Memo

To: Devin Swanberg
Date: September 1, 2023
From: Angela Popenhagen
Re: C&E Wurzer Construction – 12 Unit Apartment Building

Below is a review of the 12-unit apartment building located on Ridge Road adjacent to Kwik Trip. The information received includes a civil site plan set from Cedar Corporation dated August 2023. No architectural plans or stormwater management report was received.

SHEET NO.
C101

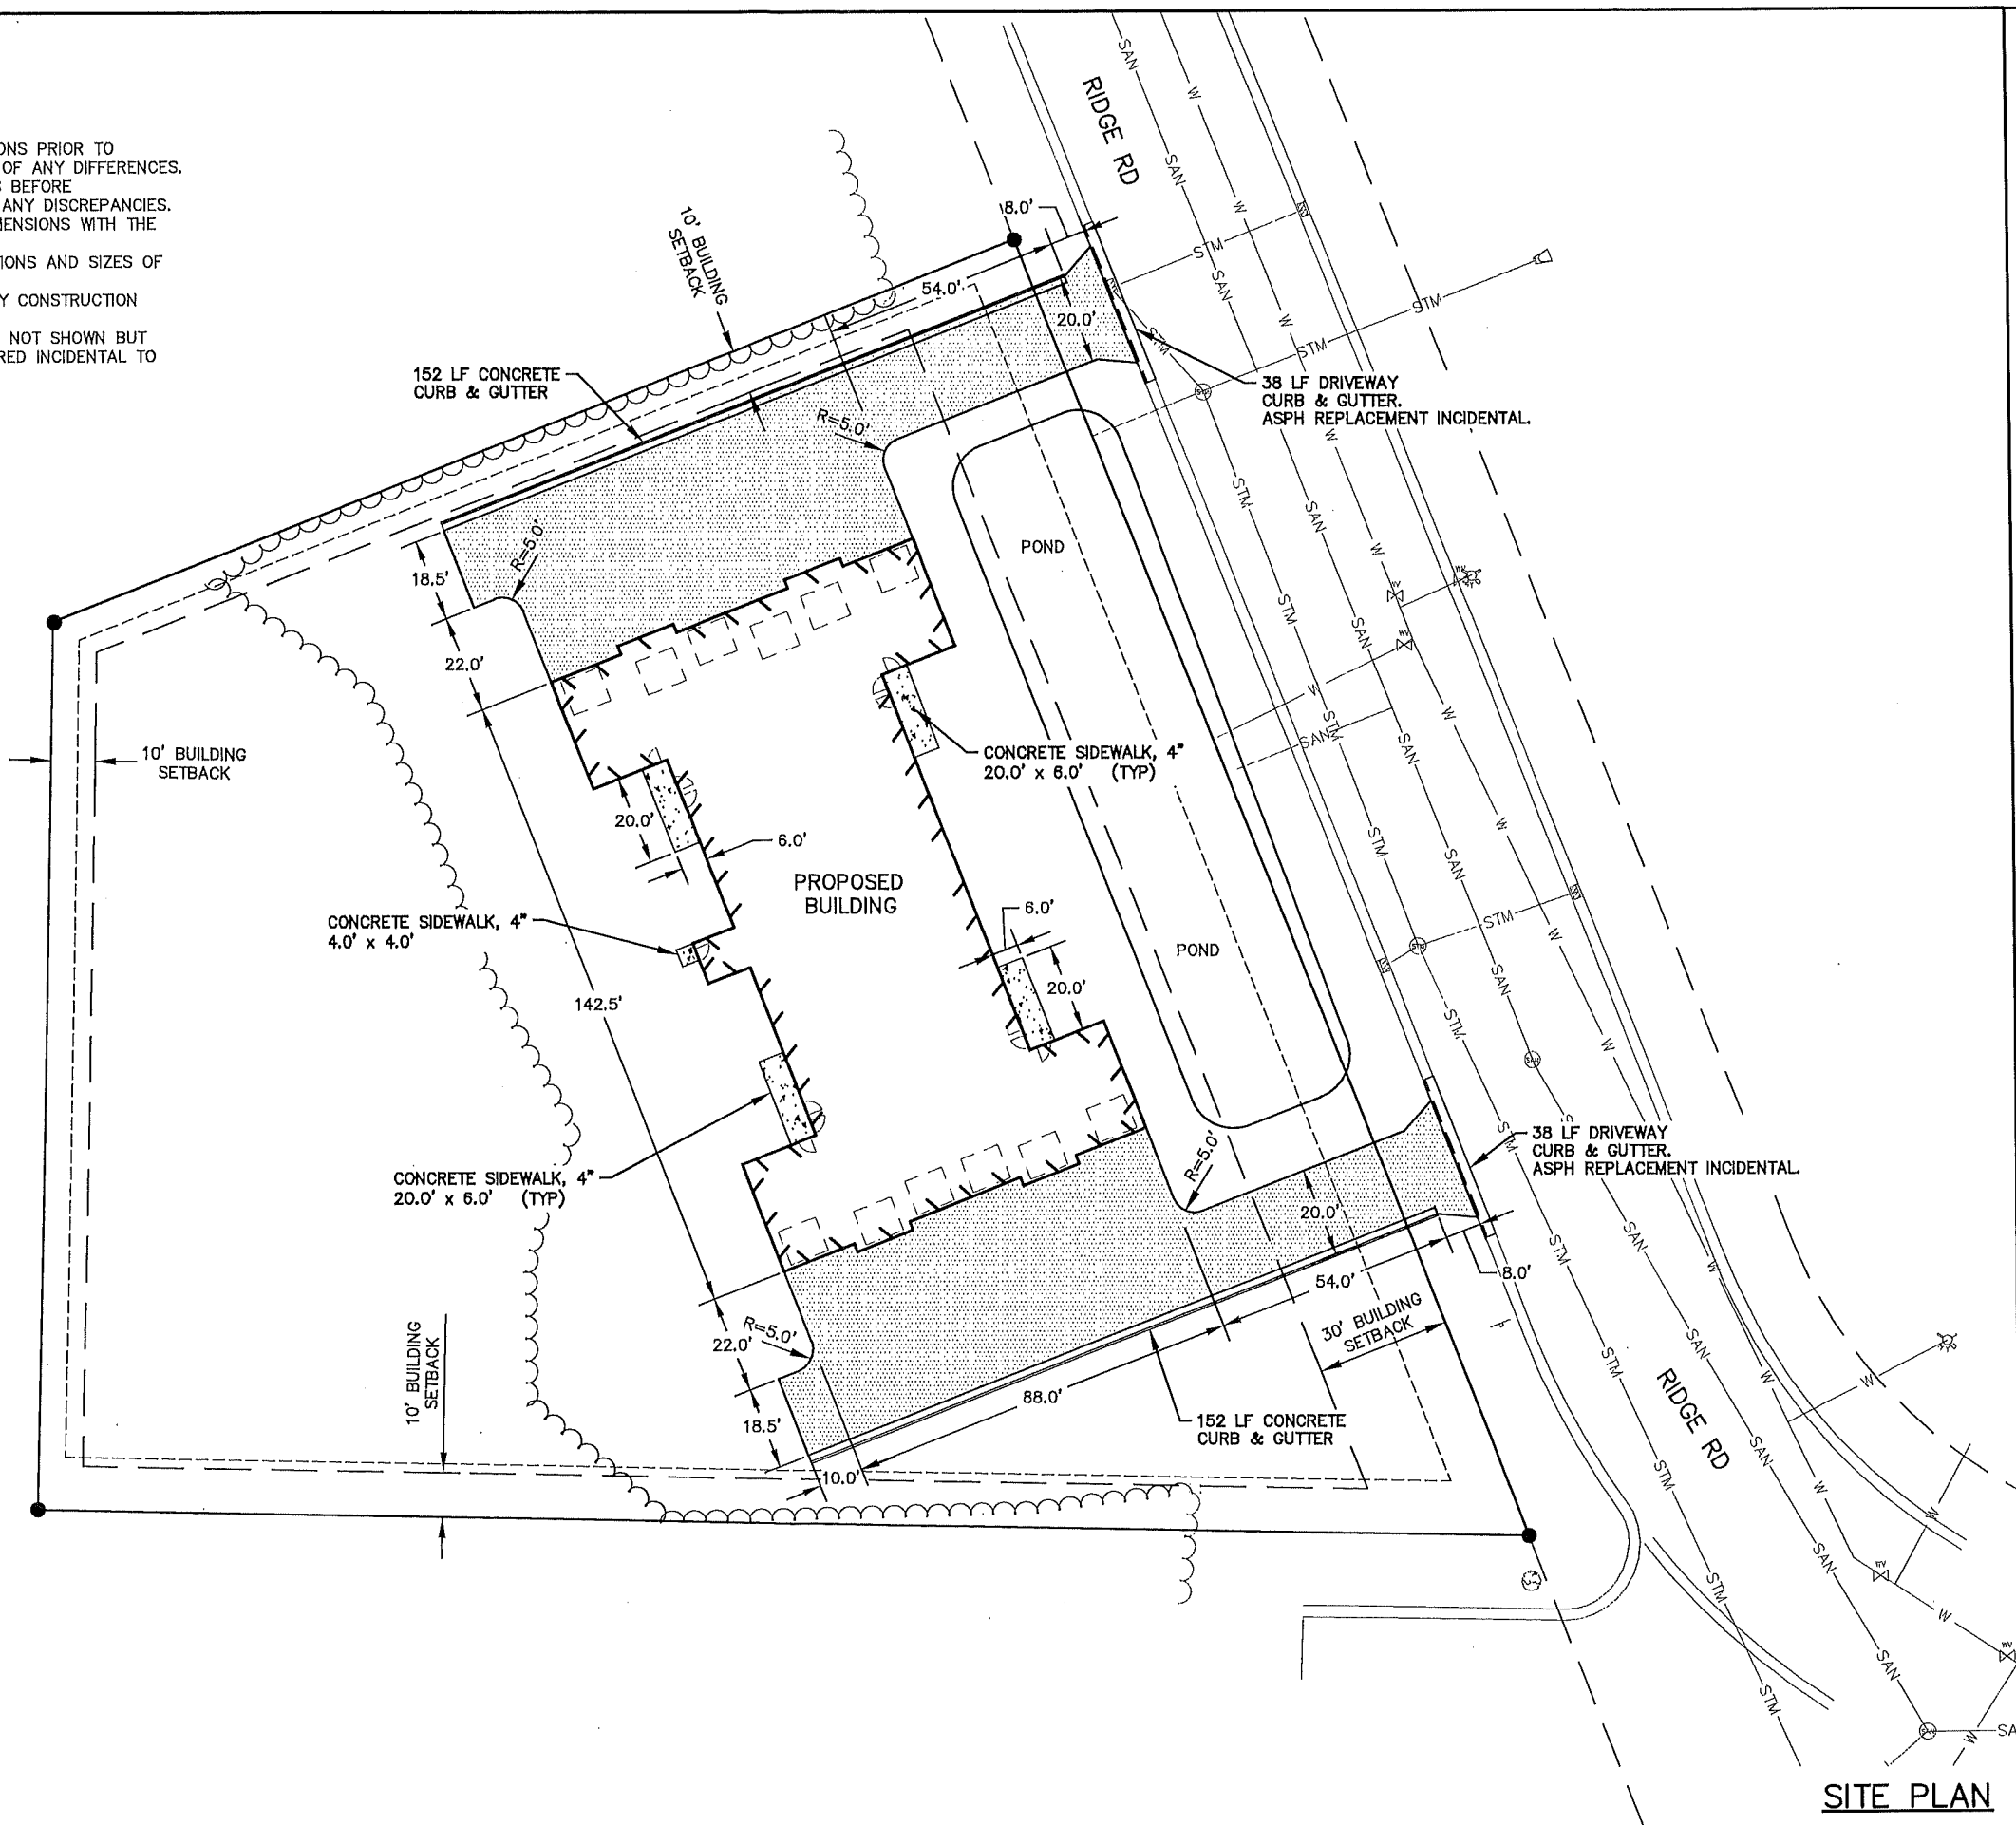
- The provided front yard setback (30-feet) and rear and side yard setbacks (10-feet) comply with the ordinance.
- The ordinance requires certain ratios to be met:

- A recreation space ratio, defined as the minimum square footage of recreation space required for each square foot of floor area, shall not be less than 0.16. This would mean that the Recreation Space Ratio = $0.16 \times 9,488 \text{ sf (approx.)} = 1,518 \text{ sf}$ is required. No recreational space is shown on the plan.

- An open space ratio, defined as the minimum square footage of open space required for each square foot of floor area, shall not be less than 2.0. The approximate open space is $46,284 \text{ sf} / 9,488 \text{ sf} = 4.9$ which is greater than the required ratio of 2.0. This is acceptable.

- An occupant car ratio, defined as the minimum number of off-street parking spaces without parking time limits required for each living unit, shall not be less than 1.5. This would mean that the Occupant Car Ratio = $12 \text{ units} \times 1.5 = 18 \text{ stalls}$. No parking is shown on the civil plans.

- A landscaping plan needs to be submitted for consideration and include planting types, quantities, layout and maintenance plan.
- A lighting plan and associated photometrics will need to be submitted for review to ensure lighting does not adversely impact adjoining properties.
- A signage plan shall be submitted for review and approval.
- A sidewalk needs to be extended along Ridge Road to connect with the sidewalk installed by Kwik Trip.
- The existing storm sewer catch basin in Ridge Road falls in the north driveway. A new "drive-over" casting will need to be installed as part of the project.
- Village of Osceola Standard Specifications and Details must be followed. Specifically, the driveway apron appears to not comply.
